PROJECT	RECONSTRUCT TERMINAL APRONS PHASE I
OWNER	NEW BEDFORD AIRPORT COMMISSION NEW BEDFORD REGIONAL AIRPORT NEW BEDFORD, MASSACHUSETTS

SHEET TITLE	TERMINAL AREA APRON PHASE I PLAN
DRAWING NO.	C1.1
5 OF 8

2016-09-26 NOI SUBMISSION

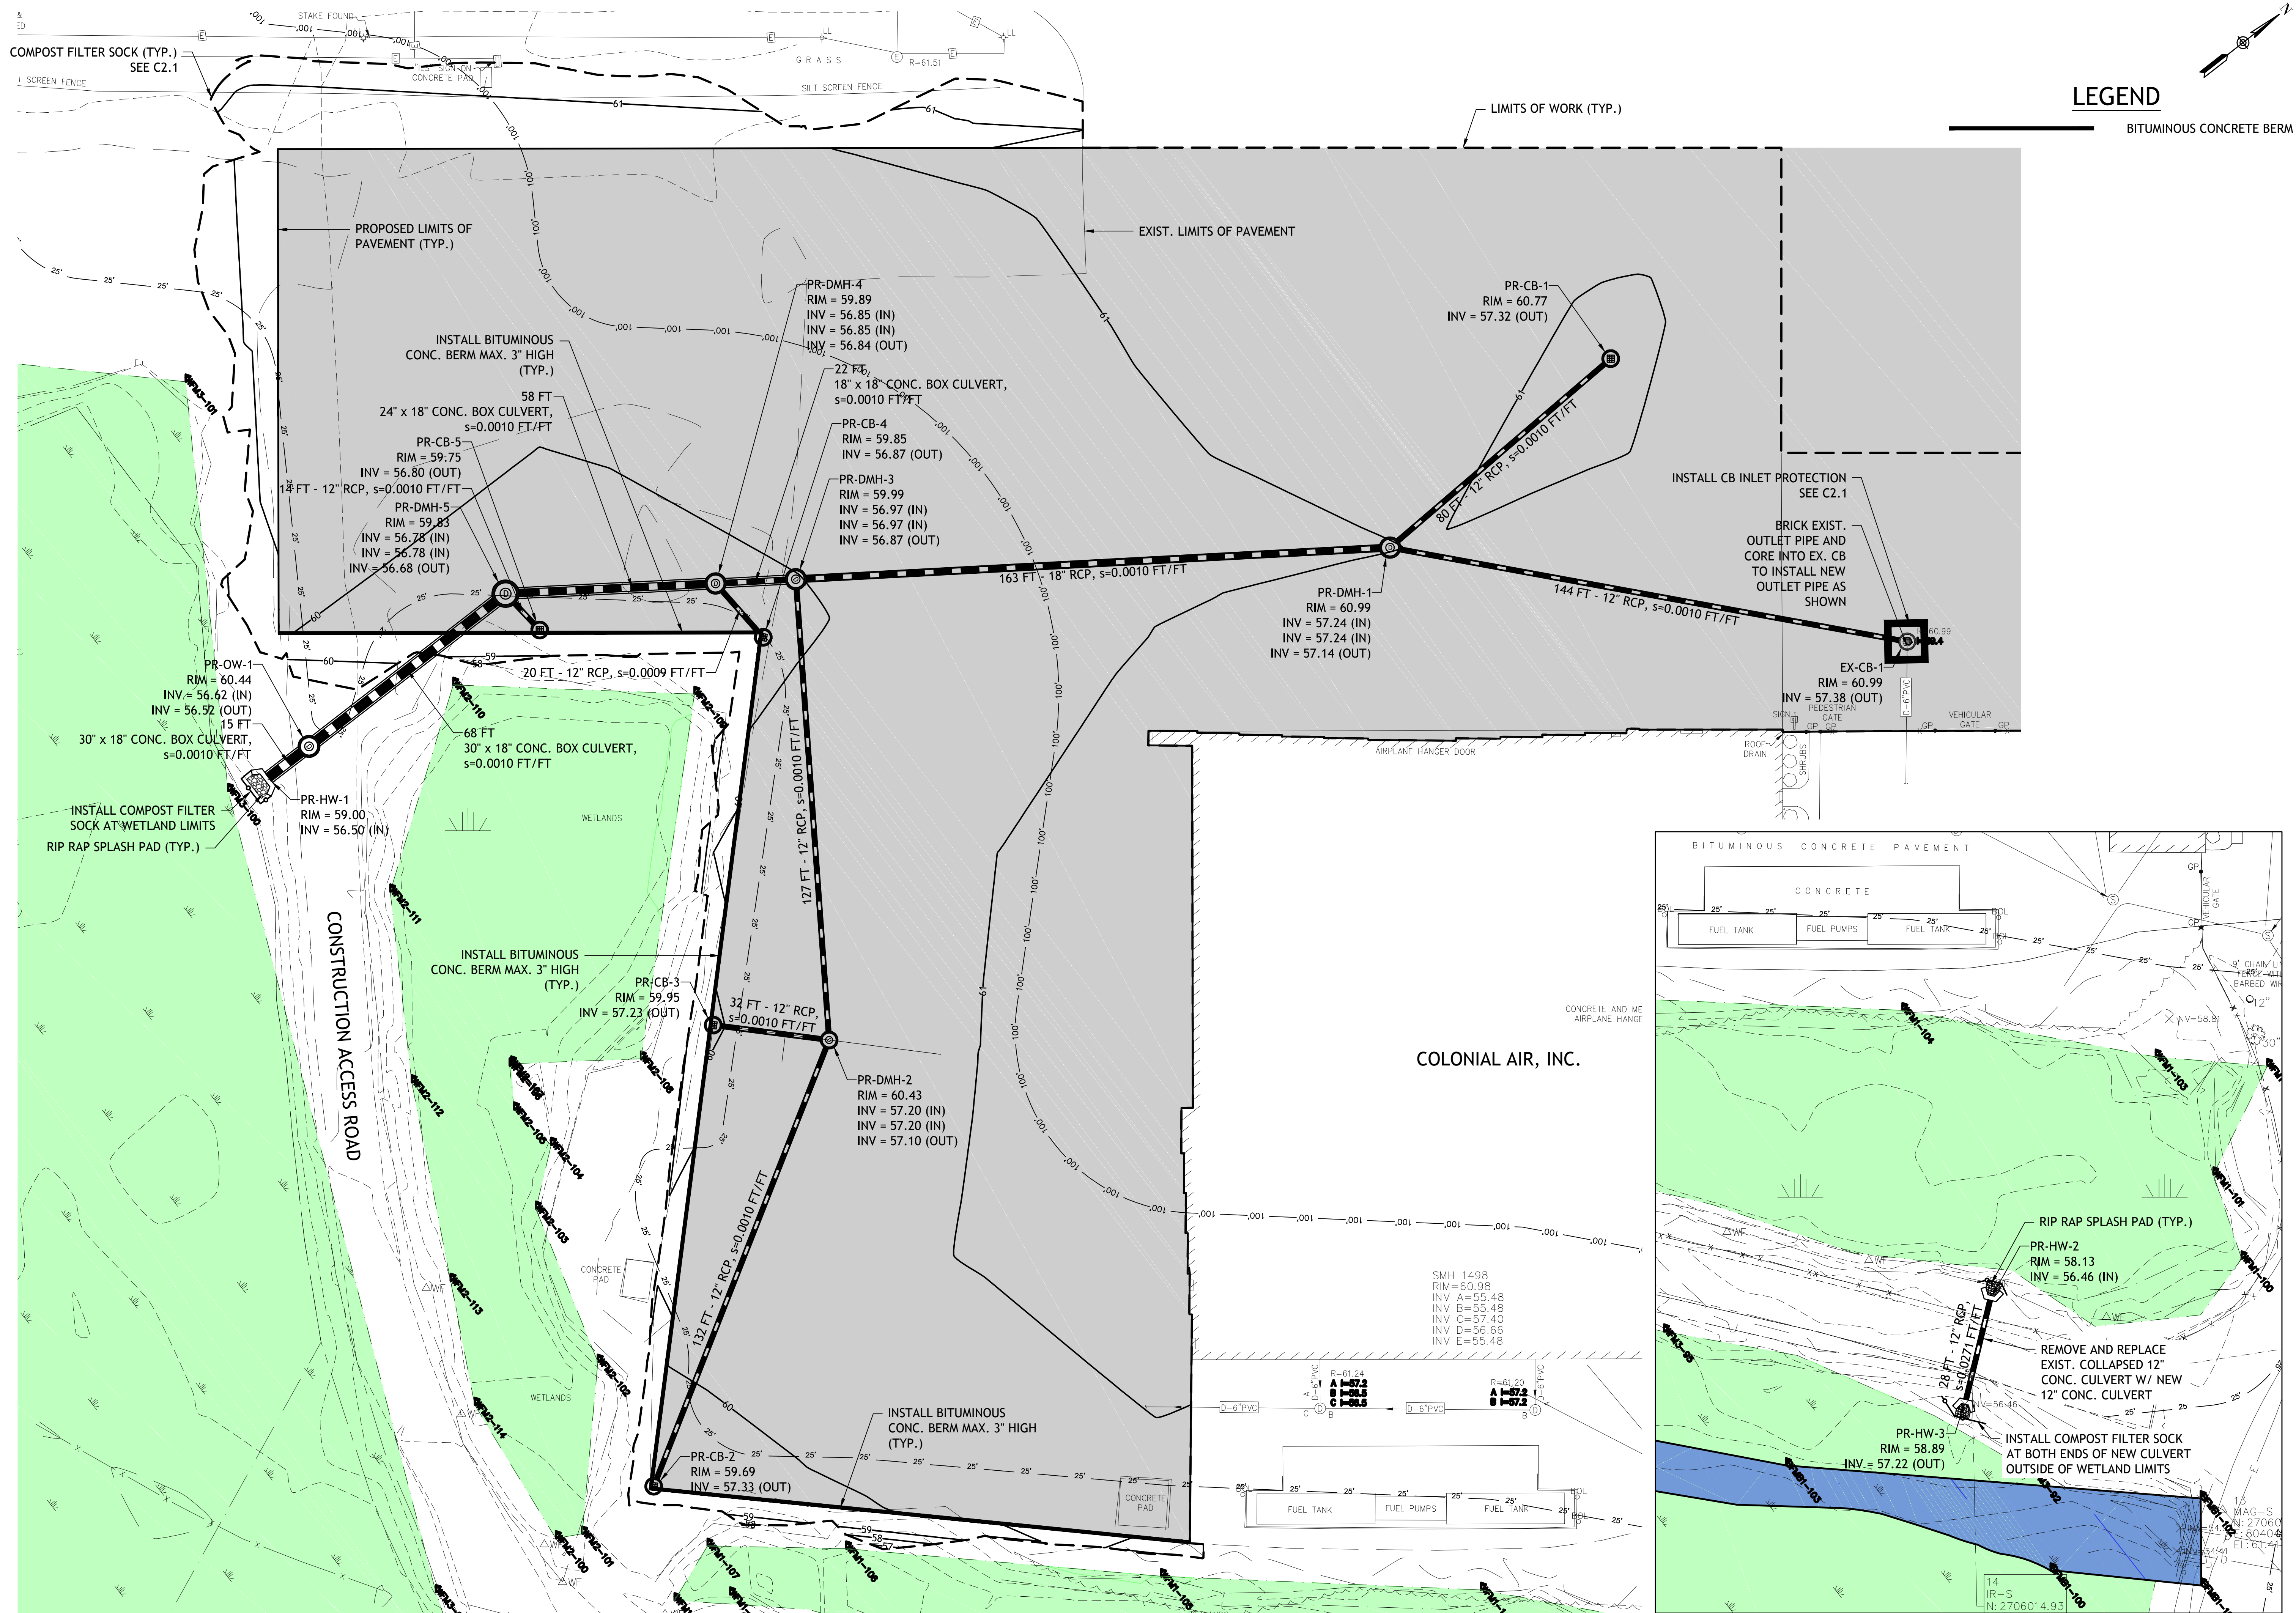
NO.	DATE	DESCRIPTION	BY
1	10/19/16	Added compost filter sock and bit. conc. berm.	MKO
2	12/15/16	Added rip rap splash pads to outlets and headwalls to culvert. Repaired existing grading to eliminate wetland impacts.	MKO
